**MONTGOMERY COUNTY HISTORIC PRESERVATION COMMISSION**  
**STAFF REPORT**

<b>Address:</b>	30 Hesketh Street, Chevy Chase	<b>Meeting Date:</b>	4/12/2023
<b>Resource:</b>	Contributing Resource <b>Chevy Chase Village Historic District</b>	<b>Report Date:</b>	3/15/2023
<b>Applicant:</b>	Jonathan Hacker & Kristen Donogue (Henry Chuang – Agent)	<b>Public Notice:</b>	3/8/2023
<b>Review:</b>	HAWP	<b>Tax Credit:</b>	Yes
		<b>Staff:</b>	John Liebertz

**Permit Number:** 936072 REVISION

**PROPOSAL:** Amendment to a previously approved HAWP for fenestration and other alterations.

*Figure 3: Example of the existing non-historic shutters, 2023.  
Source: Montgomery Planning.*

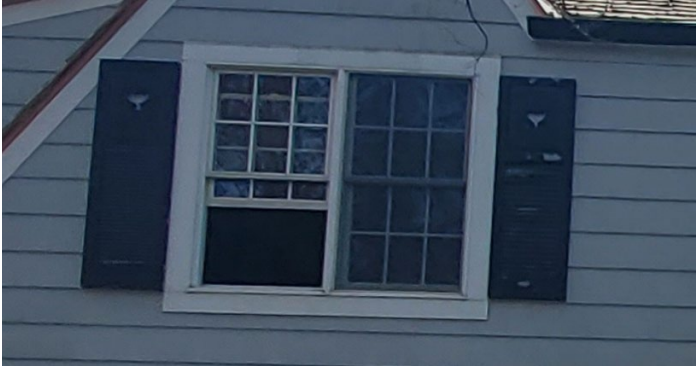
Staff finds the replacement of the shutters to be consistent with the applicable guidelines. The proposal removes the existing non-historic, non-operable, fixed wood shutters installed in the mid-to-late twentieth century. These faux shutters were inappropriately attached directly to the siding at the edge of the window casing, and in many instances, the dimensions of the shutters would fail to cover the window if operable (*Figure 3*). The proposal recalls the shutters evident in historic photographs (*Figure 2*). The proposed two-panel, louvered, operable wood shutters feature edge mounted shutter hinges (jamb hinges) and tie backs. The shutters would be sized to cover the window and folding shutters would be installed where appropriate. Therefore, the proposal restores a removed feature of the house, is compatible with the overall design of the dwelling, and is consistent with the character of the historic district.

Site Plan

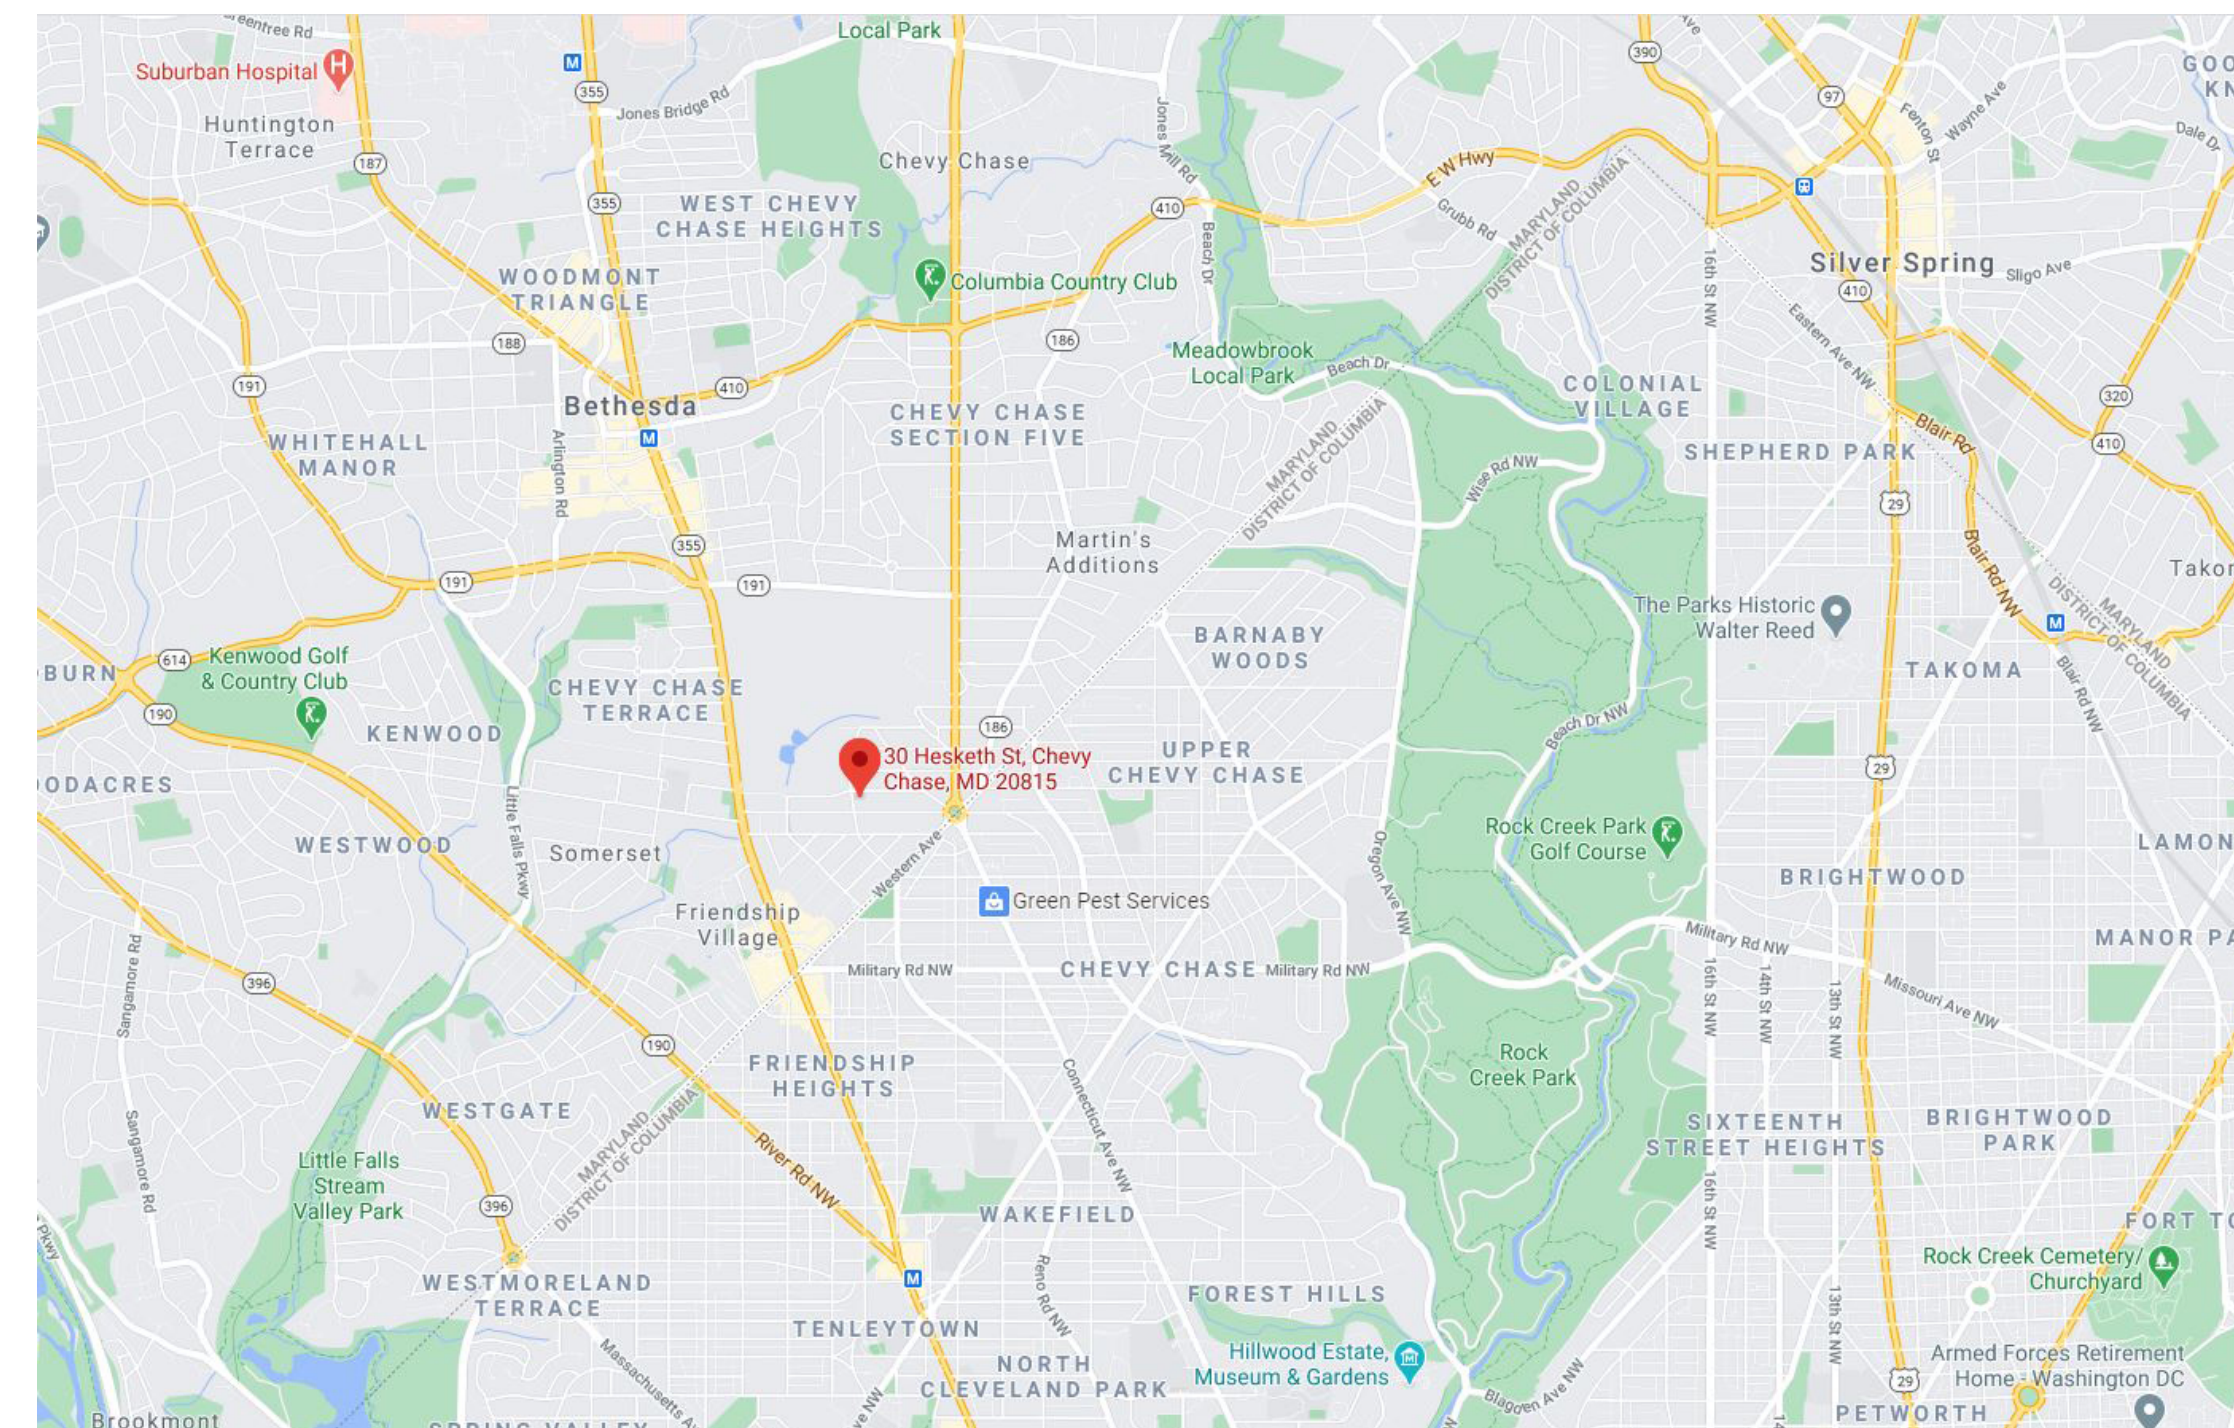
Staff finds that the replacement of the asphalt-paved driveway with a cobblestone driveway of matching dimensions to be consistent with the applicable guidelines. All final specifications for the driveway should be submitted to staff prior to the issuance of the final permit including the type of stone.

1. Specifications for the replacement of the existing asphalt driveway with cobblestone shall be submitted to staff for review. Staff will verify the compatibility of the material prior to approval of the HAWP and building permit drawings.
